# EMERYVILLE PUBLIC MARKET

# PARCEL B

# PROPOSED ALTERNATIVE

OCTOBER 31, 2019

## WIND:

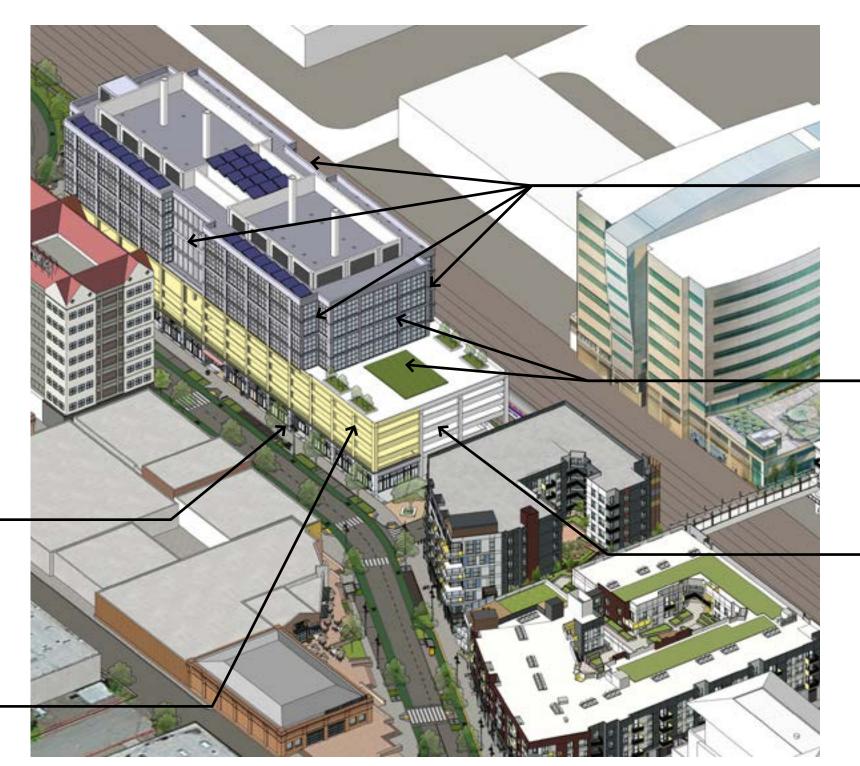
**CONCERN:** WE'VE HEARD CONCERNS ABOUT WINDY CONDITIONS AND WIND COMFORT ALONG SHELLMOUND STREET.

**RESPONSE:** THE OPEN-AIR PARKING GARAGE FORMING THE PROJECT'S "BASE" PROVIDES A BETTER RESPONSE TO WIND THAN THE SOLID BASE OF THE ORIGINAL P.D.P. (REFER TO THE WIND REPORT FOR DETAILS). STREET TREES ADD ADDITIONAL BUFFERING OF WIND TO ENHANCE WIND COMFORT.

# COMPARING ALTERNATES

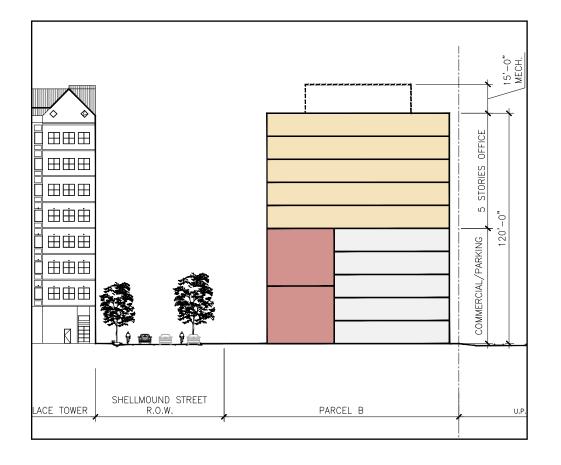
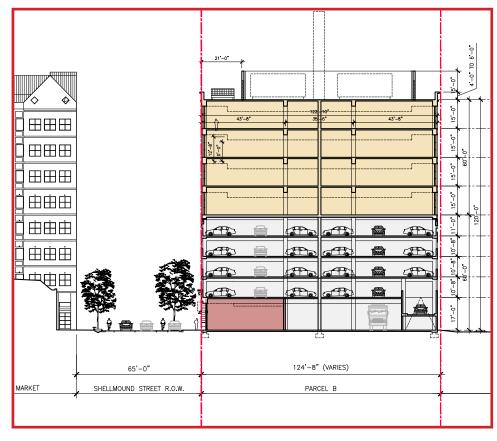
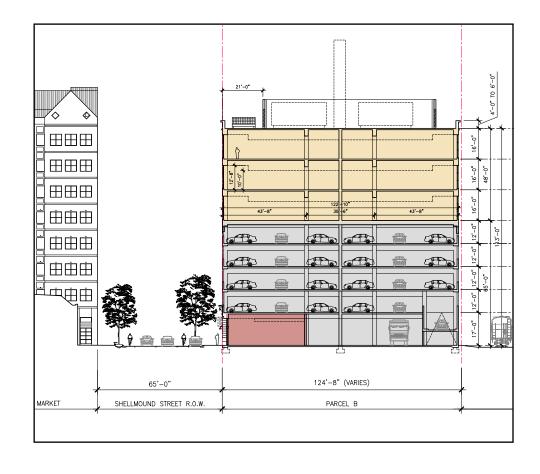
**CONCERN:** WE'VE HEARD THAT WE SHOULD AVOID THE OVER-PROVISION OF PARKING TO REINFORCE TRANSIT.

**RESPONSE:** WE'VE CUT BACK THE SIZE AND CAPACITY OF THE PARKING STRUCTURE BY 10%, WIDENING THE GAP AT THE BASE COMPARED TO THE APPROVED JANUARY F.D.P.
